Response to PL/2023/10332 Land South of Potterne Park Farm, nr Potterne, Devizes, Wilts, SN10 5QT

Application Reference: PL/2023/10332

L1: Visibility from the Wessex Way to the South West of the site needs to be addressed.

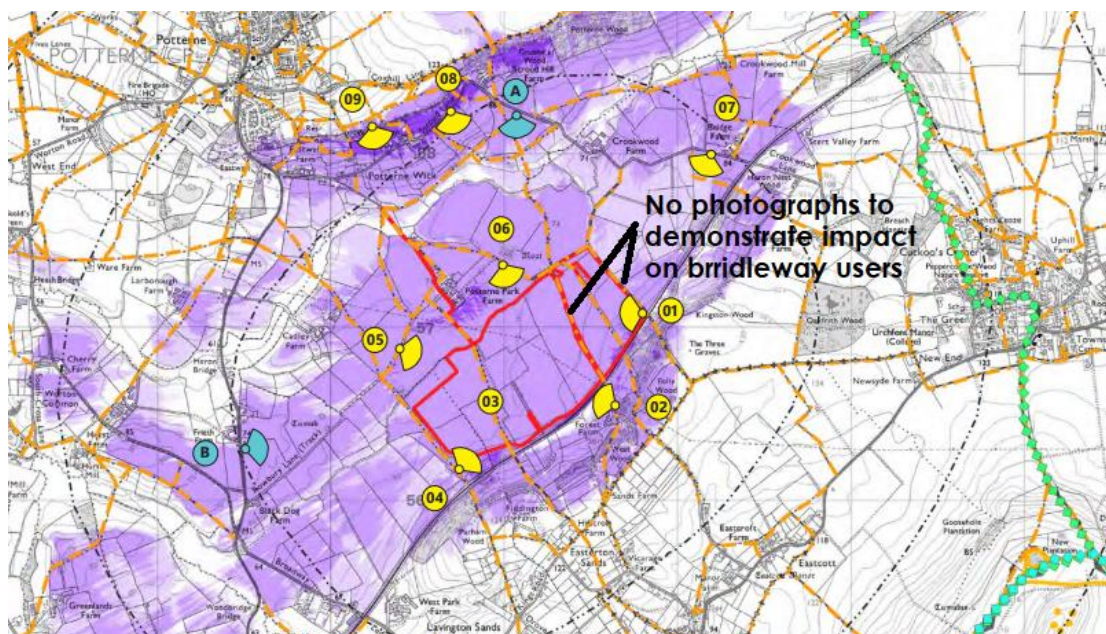
- 2.9 It is clear that there are additional factors that make the LVA for the proposals insufficient to allow the full impact of the proposals to be assessed. The extracts from the LVA below illustrate how the visual amenity of local residential properties have been ignored; how the higher ground to the south of the site was clearly visible in the landscape assessment photos (Strawberry Hill for example); how alterations to the site boundary in this area of the south kept this area out of the 'zone of visibility' and how the impact of users of the rights of way (both on foot and on horseback) have not been sufficiently addressed.

L2 and L3 below: Dwellings where impact has not been addressed

L7: Extracts from Plan LH22-067 DW3 (Proposed Substation Layout and Details)

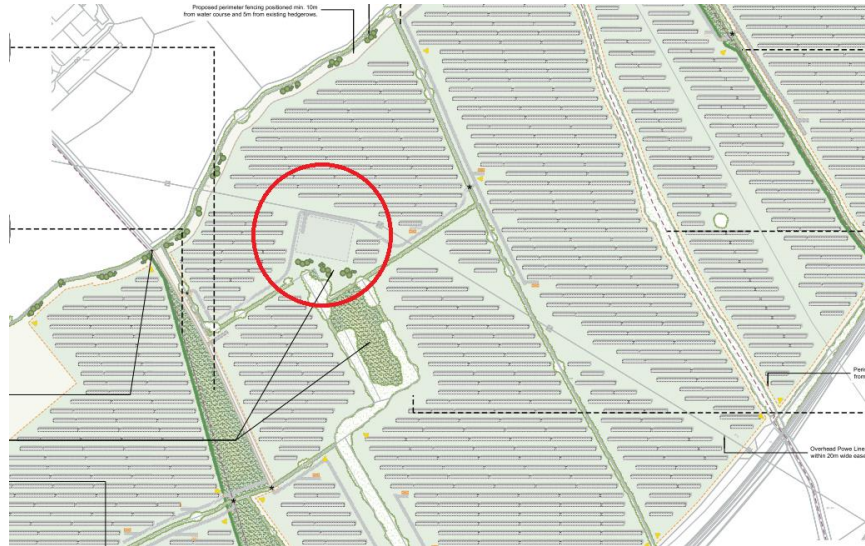
- 2.13 Another unreliable and erroneous aspect of this Landscape and Visual Appraisal is the total disregard to the height of the structures in the proposed substation, in addition to the height of the CCTV cameras. The substation includes a 15m high radio mast, a 3.4m high building, 2.4m high galvanised security fence, floodlights, transformers, disconnectors, and other electrical structures (between 7.2m and 8.8m high) and floodlights or the CCTV cameras on 5m poles around the site. The main assessment criteria are based on the 3.2m solar panels only. Furthermore, the Zone of Theoretical Visibility then lowers this height to 3m for theoretical screening. It is totally unrepresentative and misleading to use a lower screening value than the height of the solar panels, let alone neglecting to assess the impact of this industrial compound in open countryside.

- 2.14 These plans suggest the overall area for the electrical structures is 45m x 61.8m (2,781m²), with an additional 38.6m² of control room, with further agricultural land taken for the access road, 15m control tower and cess pit. **This will clearly have a significant and major adverse landscape impact.**

L9 & L10: The lowering of the ZTV from 3.2m to 3m

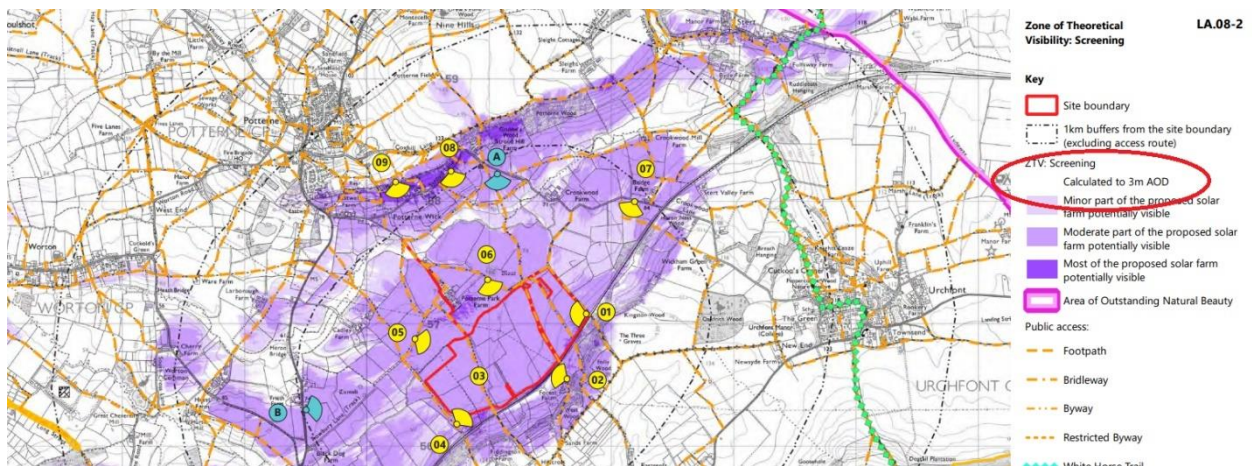
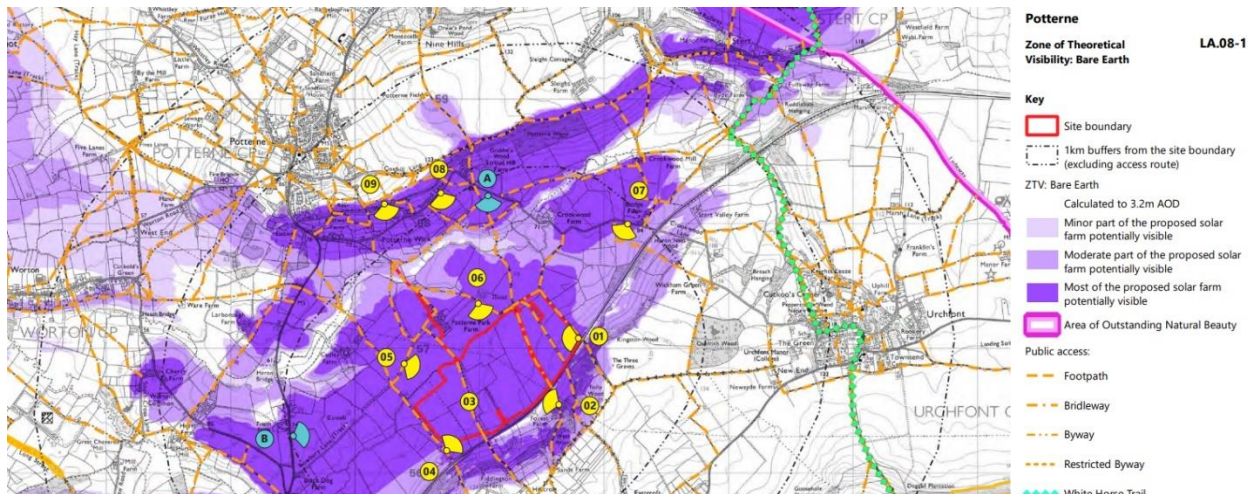
L8: Location of the Compound (Block Plan Extract)

Figure E4 – Extract from the MAGIC Map

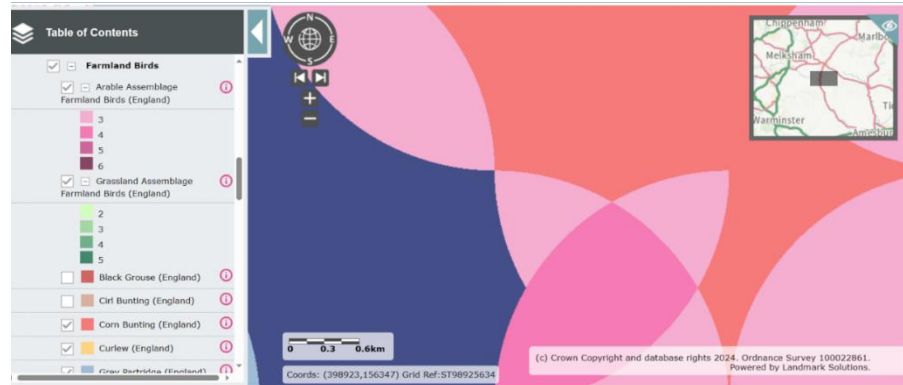
- 3.19 Para 3.3.4 of the Ecological Impact Assessment highlights that a number of notable bird species are probably breeding on site and it is considered to be of Local importance for breeding birds. However, the MAGIC designation highlighting the BCTP suggests that the site has wider existing importance or the potential to be of wider importance. The Bird Conservation Targeting Project (BCTP) produces breeding distribution maps for a suite of rare and declining farmland and/or woodland birds. The maps can be used to guide the prescription of land management advice based on the species already breeding in an area, or for allocating funding towards sites known to be important for birds. This extract from the MAGIC database indicated that the site is important for Corn Bunting and Lapwing.

D&A 5: Other potential solar farms in the area

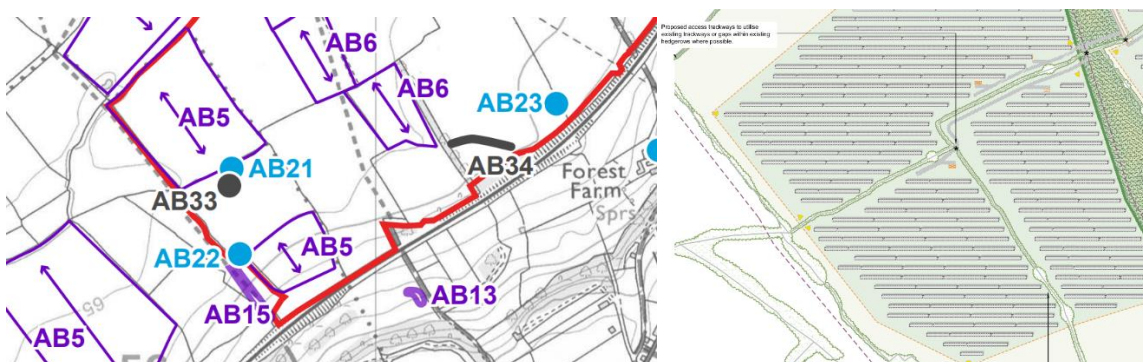
- 7.5 The screening opinion appears to suggest that there may be another potential solar farm or large development at that needs further information on. The Wiltshire Council Screening report provides this map. Information is available for the Blounts Court Farm proposal, although there also appear to be at least 2 other proposals in the area (see orange circles).

A1: Extract From Figure 2: Cultural Heritage Features Map and Site Block Plan

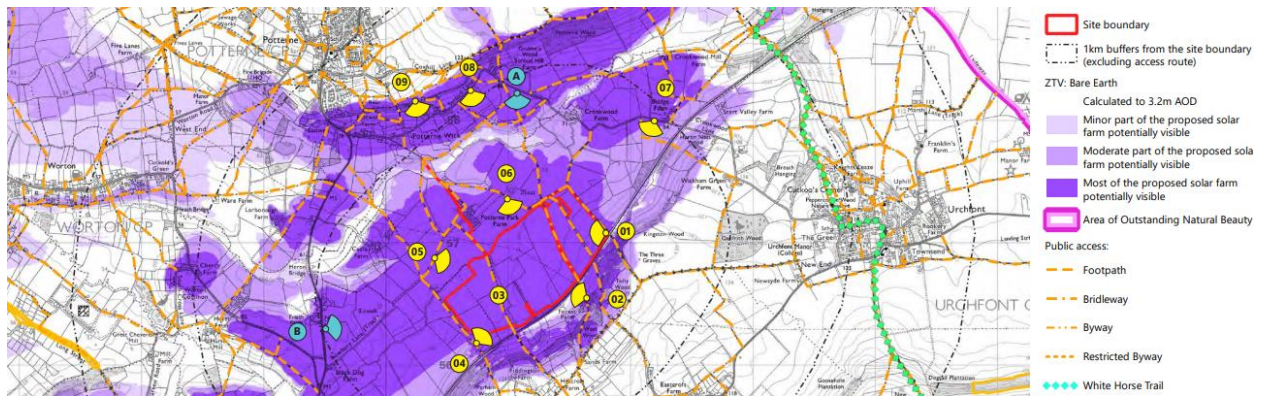
- 8.2 The assessment references a Geophysical survey, that identified a cluster of linear features in the NW corner of the site, which were apparently consequently removed from the application designs (AB33). There is no evidence of this mitigation, as the extract from Figure 2: Cultural Heritage Features Map and the Site Block Plan illustrate:

A3: Extract from the Zone of Theoretical Visibility from the Landscape and Visual Appraisal (note there is no assessment of the substation in this Appraisal)

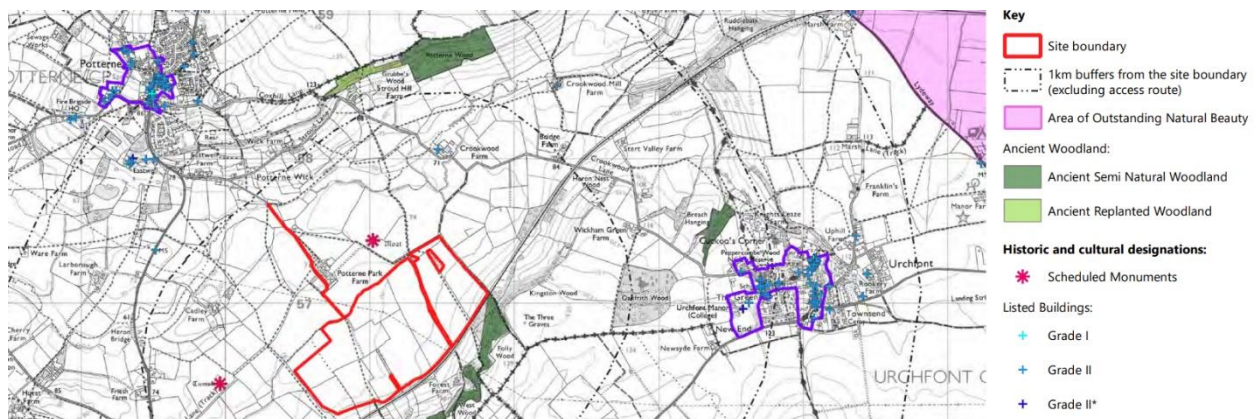
A2: Viewpoint 06 from the Landscape and Visual Appraisal – taken from the footpath that runs alongside the SAM.

A4: Listed Buildings in the Surrounding Area

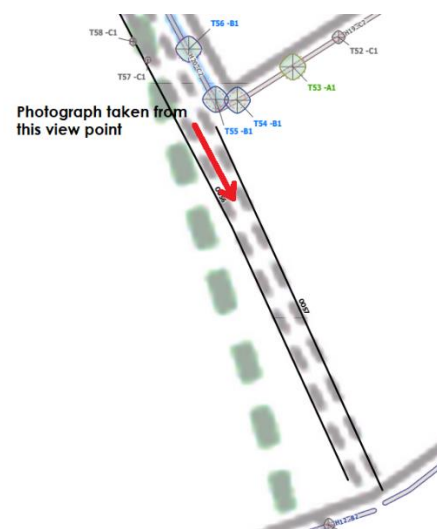
- 8.6 There is also a potential risk to the SAM not only through the industrialization of the surrounding farmland, but also through changes in surface water/hydrology of the area (see Section 12 below). The impact on the setting of listed buildings beyond the 1km radius is also important. This large-scale development will significantly affect the setting of the surrounding listed buildings with views across the site; especially as the full impact of the proposed substation has not been assessed.

Figure 4.7: Typical Solar Farm Compound Layout

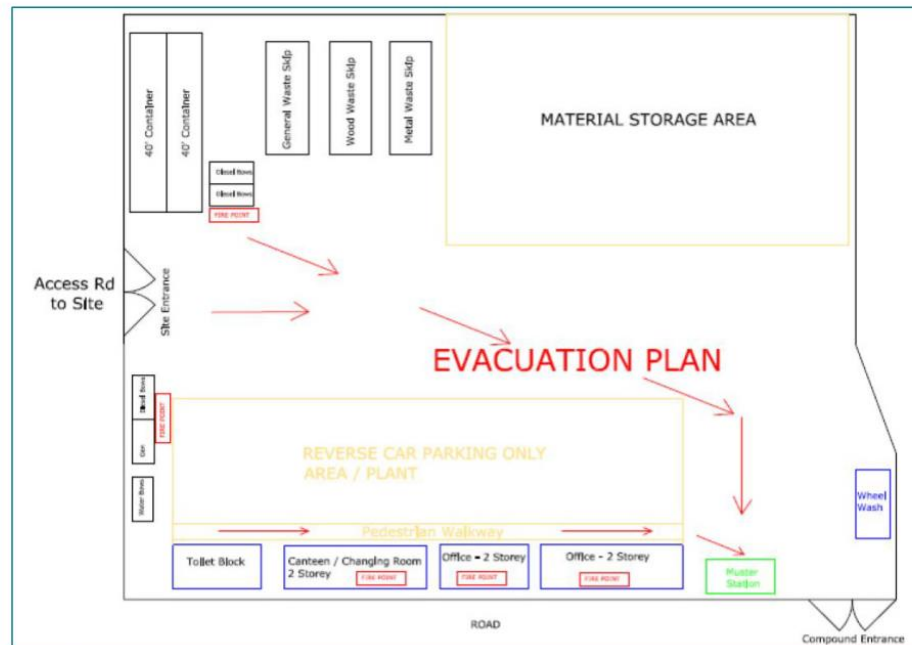
11.5 More information is required about the location of the 40 x 30 m compounds:

11.8 The calculation of Construction Traffic Movements is flawed, not only in the under-estimation of the delivery of stone, but also for the equipment/structures in the compound(s). The indicative plan of a compound includes a range of equipment and structures such as 2 x 40ft containers, skips, canteen, toilet, offices. No traffic movements have been included for the compounds. More accurate figures are required.

Figure 1: Site location plan.

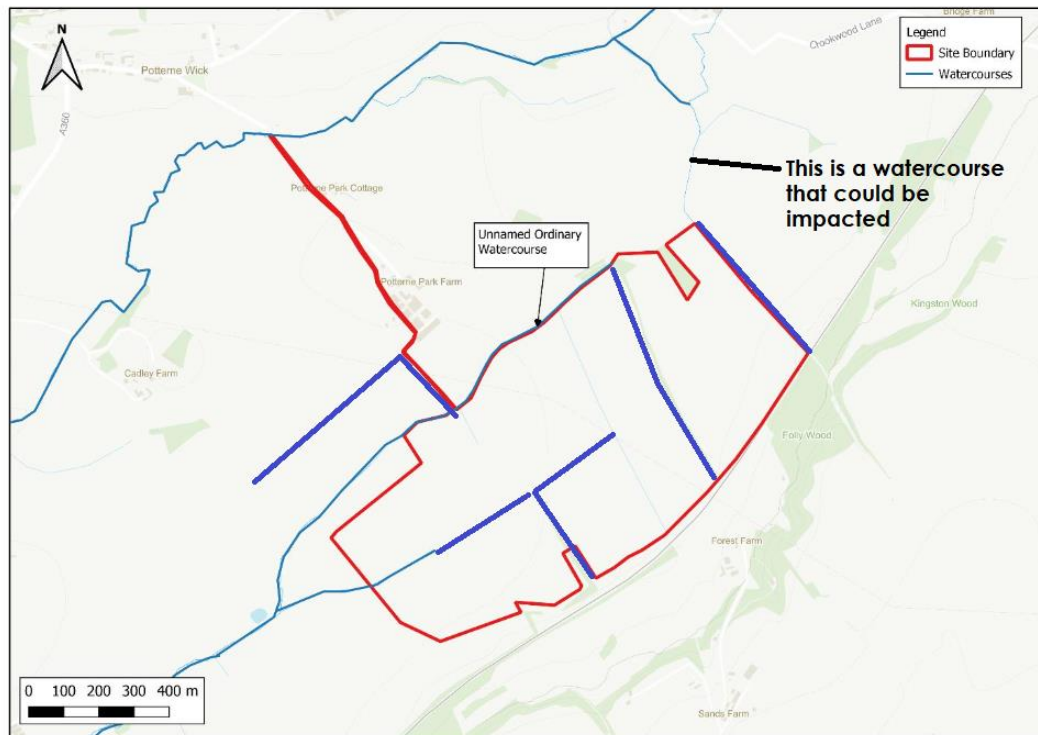
- 12.2 There are many simple inaccuracies in the assessment. At Paragraph 2.1, the site is described as entirely arable land, however it is a mix of arable and pasture land. No reference is made to the existing agricultural land drainage system, with the main running parallel with all the hedge lines. There are a number of watercourses that have been omitted from the assessment (see Figure 1 below), yet can be found marked on in the Ecological Impact Assessment. Some of these may be fed by the agricultural drainage system, but as such are equally relevant to the assessment. The drainage system will be damaged/destroyed by trenching to 1.2m deep, the proposal to bore some of the cables under the hedges/trees, in addition to piling the solar panels 1.2m into the soils.

Figure 4: EA Surface Water Flood Risk Mapping

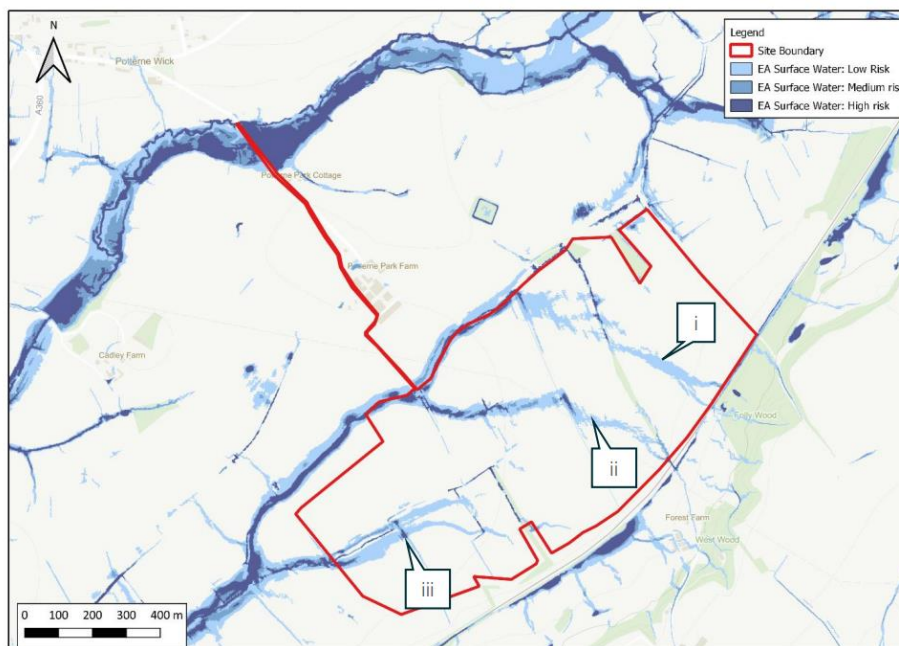
- 12.3 This FRA appears to be a desk-based assessment which is underestimating the flood risk. There is no acknowledgement that the field capacity of the site is limited, as illustrated by the prolonged periods that the site has surface water flooding. Climate change will cause more extreme weather events and there is no evidence to prove that the proposed large scale solar farm will not exacerbate this. Indeed, the on-site evidence suggest that it will exacerbate future on and off-site flooding.
